## **DETAILED ACTION**

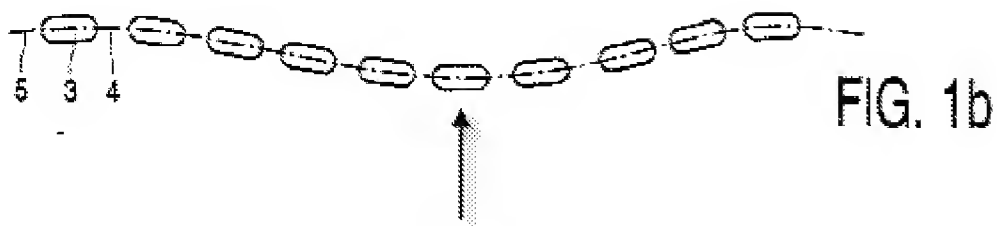
In the above figure from Oostveen, a pregroove pit area is located at a peak value of the wobble, indicated at the arrow. It is clearly the case though that it is only a minority of pregroove pit areas that match this criterion.

As indicated in the above figure from the case at hand, it is clearly indicated what is meant by having the majority of pregroove pit areas are located at the peak values of the wobble.
